Keowee Overhead emergency power path seismic qualification & analysis request for addl info.....

RE: Oconee Nuclear Station  
Docket Nos. 50-269, -270, -287

KEOWEE OVERHEAD EMERGENCY POWER PATH  
SEISMIC QUALIFICATION AND ANALYSIS  
REQUEST FOR ADDITIONAL INFORMATION

Figure 1

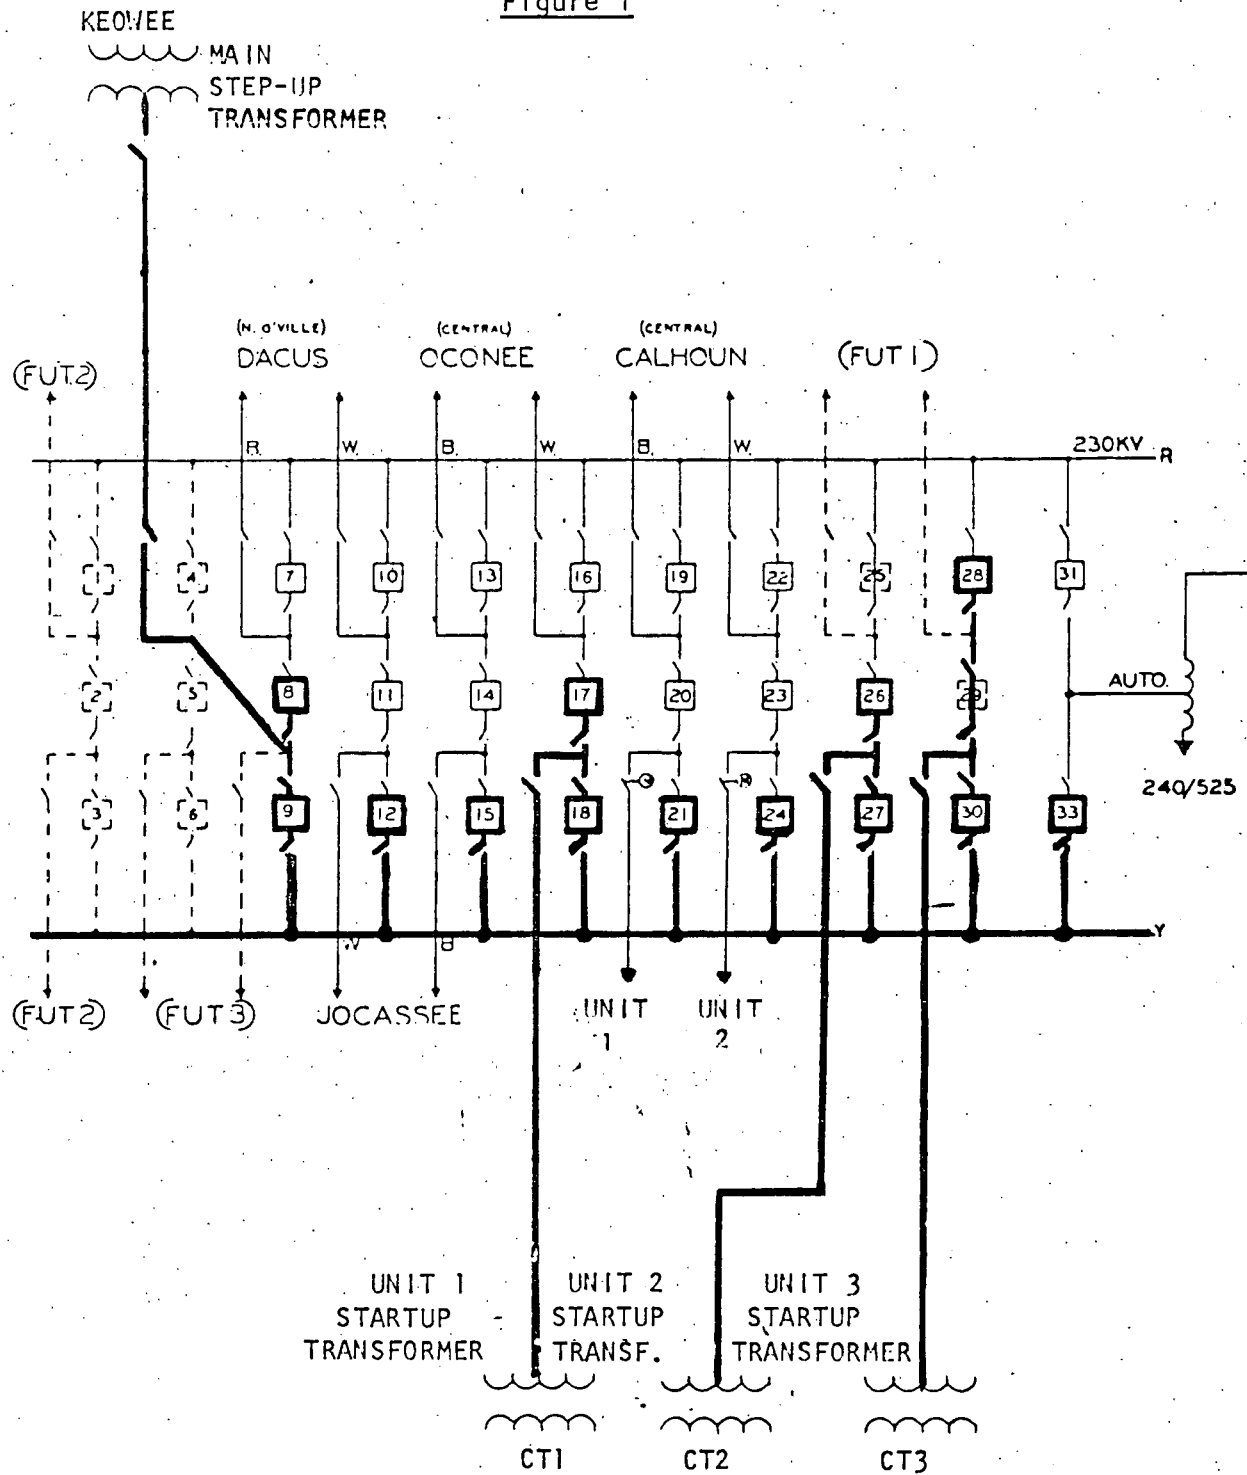
The Keowee overhead emergency power path consists of a transmission line from the Keowee main stepup transformer to the Oconee 230kV switchyard; one 230kV switchyard bus system including power circuit breakers, disconnect switches, and associated controls; and overhead lines from the Oconee 230kV switchyard to the Oconee startup transformers.

The Keowee overhead emergency power path interfaces with the Keowee main stepup transformer; 230kV switchyard power circuit breakers (numbers 8, 12, 15, 17, 21, 24, 26, 28, and 33); and the Oconee startup transformers (CT1, CT2, and CT3). This overhead emergency power path interfaces have the same seismic qualifications as the systems or equipment of the path itself.

The Keowee Overhead Emergency Power Path is shown in bold lines on Figure I.
